2015 - 2016 Corvette: Service Bulletin: #16-NA-014: Delayed Engagement After Sitting With Engine Off

#16-NA-014: Delayed Engagement After Sitting With Engine Off - (Jun 28, 2016)

Subject: Delayed Engagement After Sitting With Engine Off

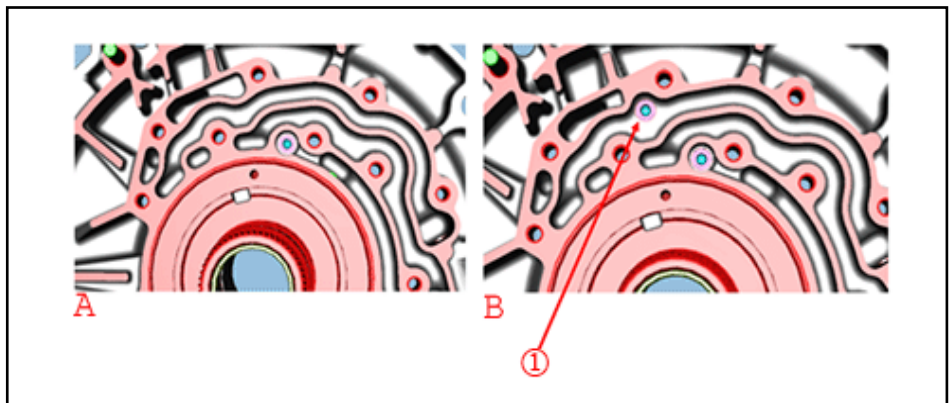
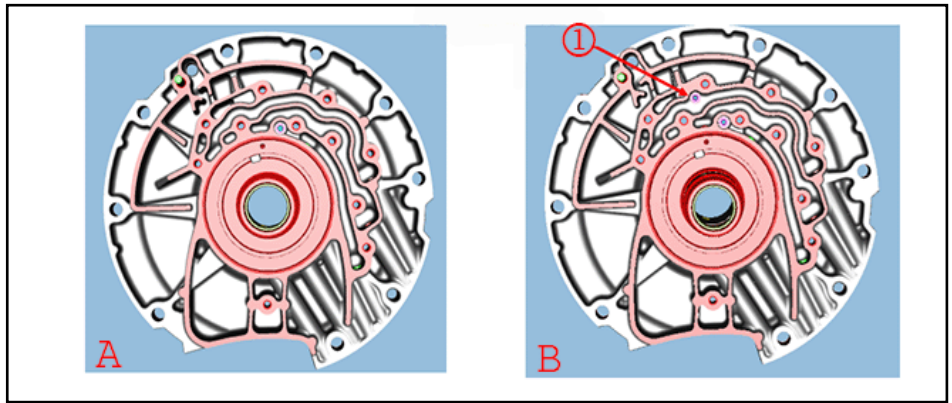
Note: The new stator shaft support assembly has a second check ball (1) added (see illustrations).

Install a new stator shaft support assembly that includes an additional check ball. Follow the instructions below to replace the stator shaft

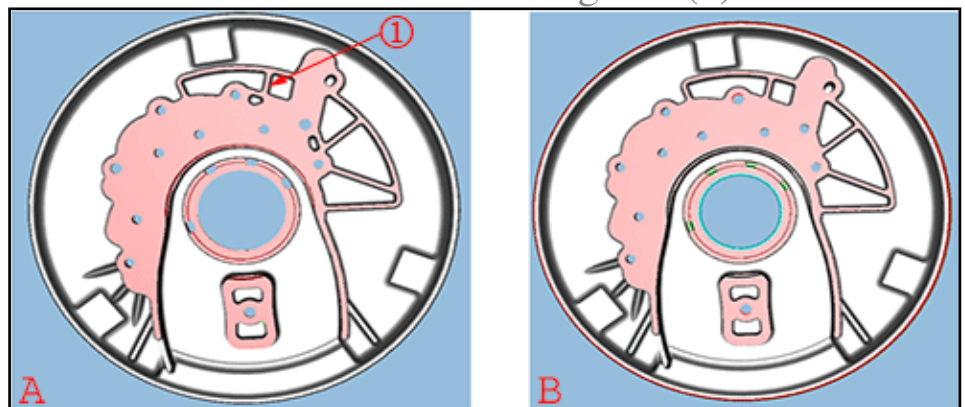
Note: The casting void has been eliminated from the underside of the cover for the 8L90 only (see illustration). The 8L45 is not required.
